FRANKFORT IND – PHASE 4 AUDITORIUM RENOVATION

BG 24-050

ADDENDUM NUMBER ONE

29 Feb 24

11
 A-3-03

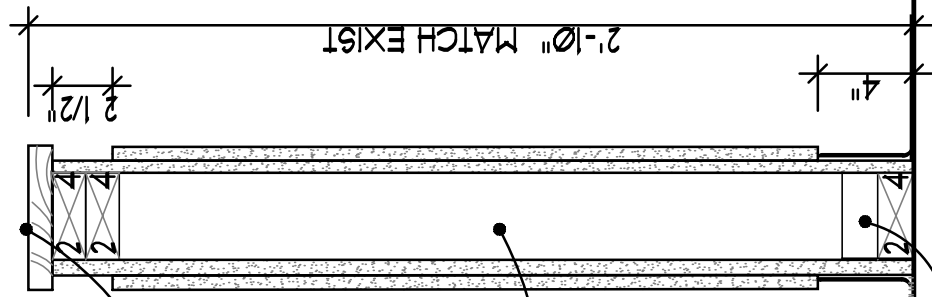
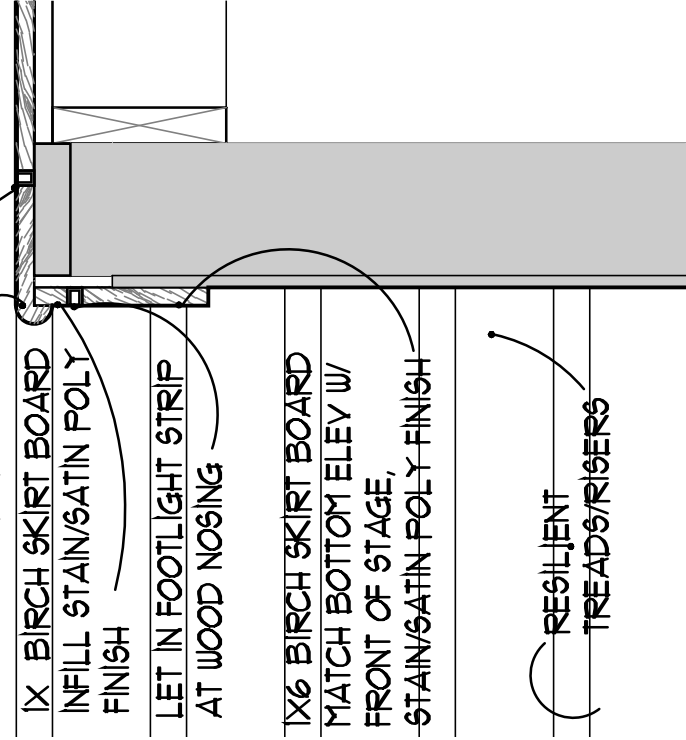
6" x 1" BIRCH CAP
 PAINT FINISH TURN DOWN
 TO FLOOR AT END

2 LAYERS 5/8" GYP BD
 EA SIDE ON 2x4
 FRAMING

CARPET ON 1/4"
 UNDERLAY ON 3/4"
 PLYWD SUBFL

3"x3"x3"x1/8" ALUM ANGLE
 AT OPEN END BEHIND
 TRIM OR GYP BD
 ANCHOR W/ 1/2" SS
 SCREWS MIN 4 EA FACE.

LET IN FOOTLIGHT STRIP
 AT WOOD NOSING

SUPPLEMENTAL DWG 13
FRANKFORT HIGH SCHOOL
DET 13/A-3.03

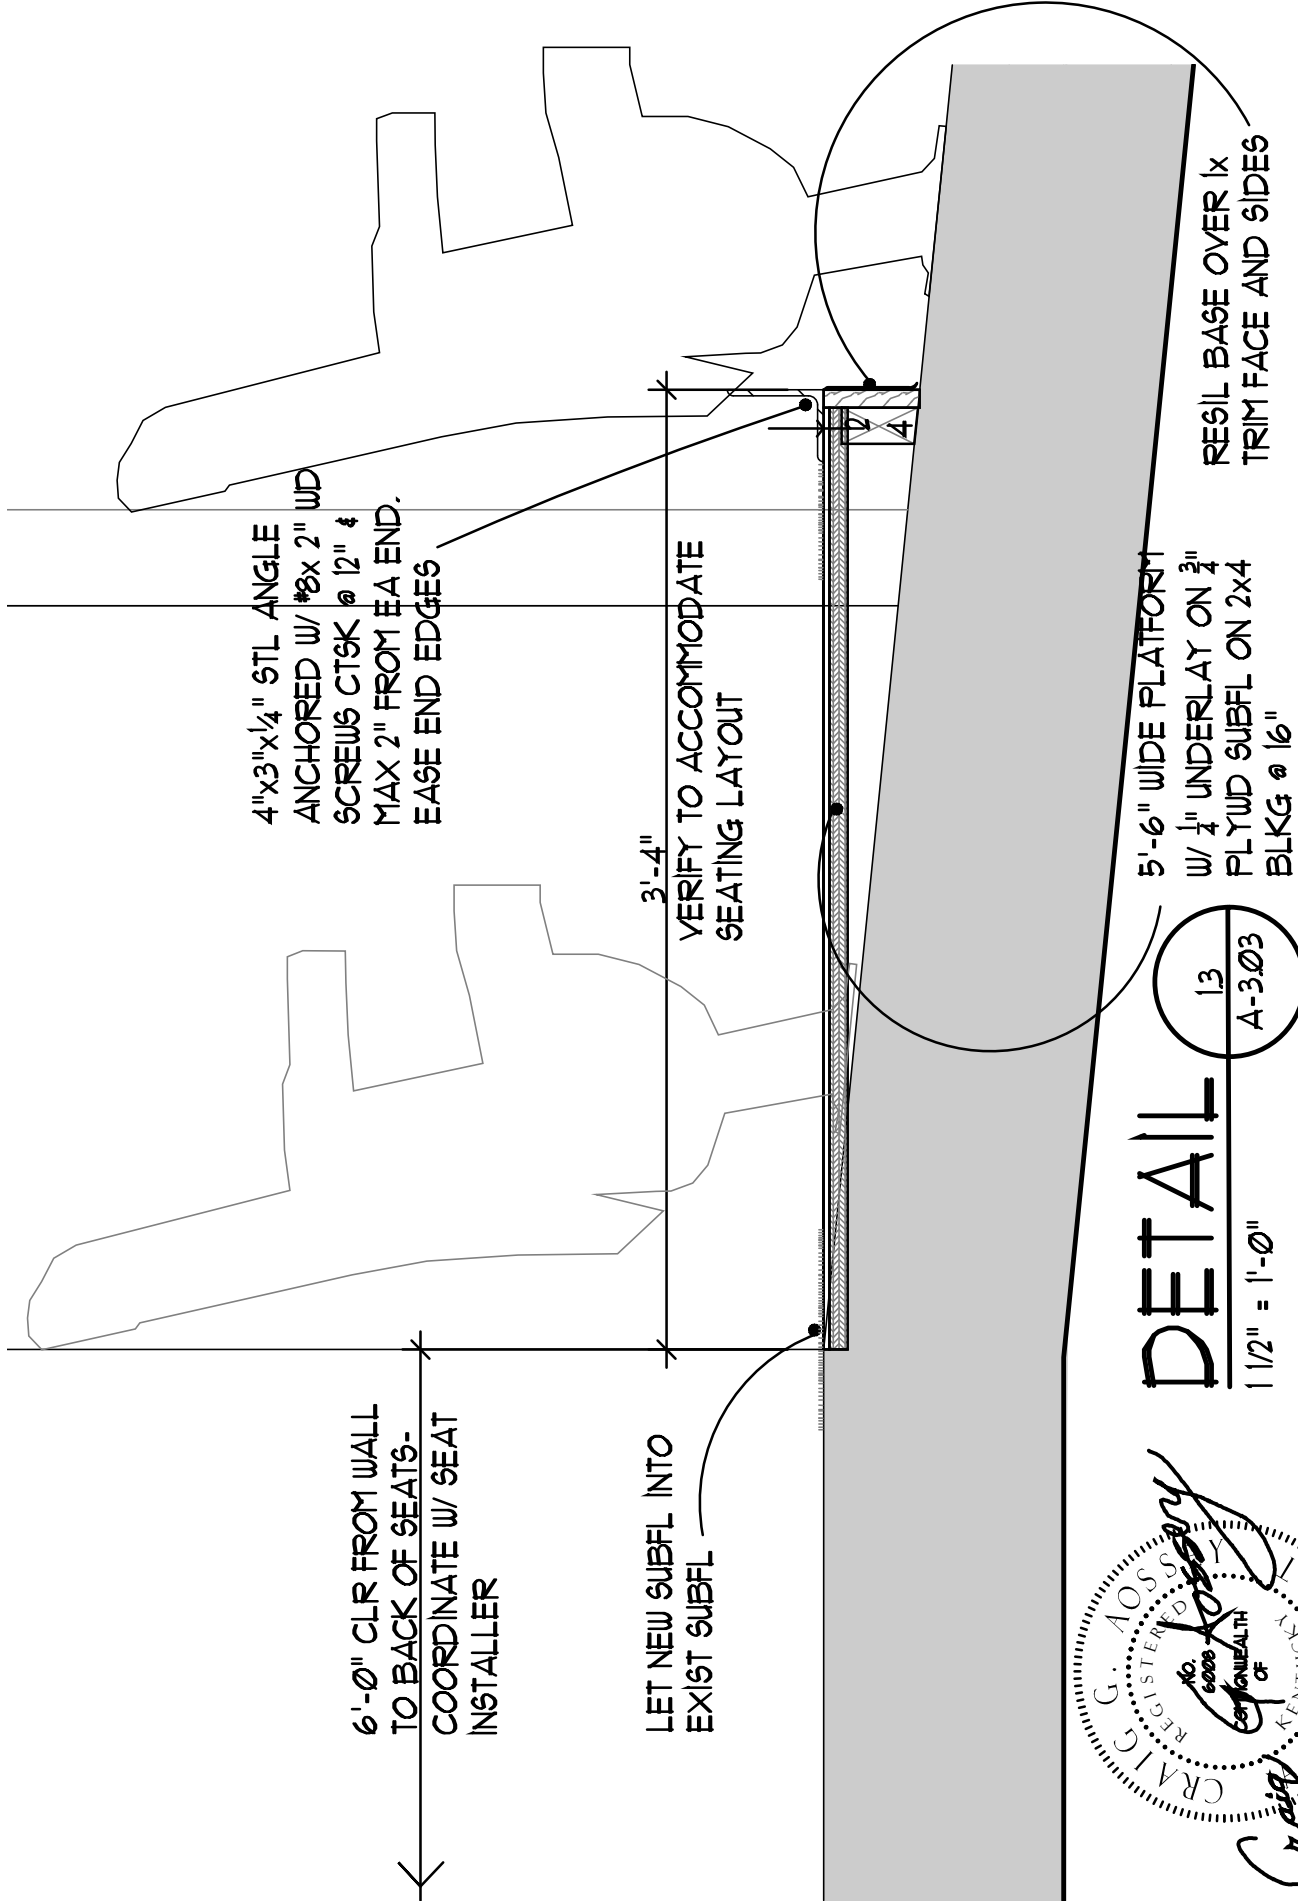
5'-6" WIDE PLATFORM
W/ 1/4" UNDERLAY ON 3/4"
PLYWD SUBFL ON 2x4
BLKG @ 16"

3'-4"
VERIFY TO ACCOMMODATE
SEATING LAYOUT

4" x 3" x 1/4" STL ANGLE
ANCHORED W/ #8 x 2" WD
SCREWS CT9K @ 12" &
MAX 2" FROM EA END.
EASE END EDGES

6'-0" CLR FROM WALL
TO BACK OF SEATS -
COORDINATE W/ SEAT
INSTALLER

LET NEW SUBFL INTO
EXIST SUBFL
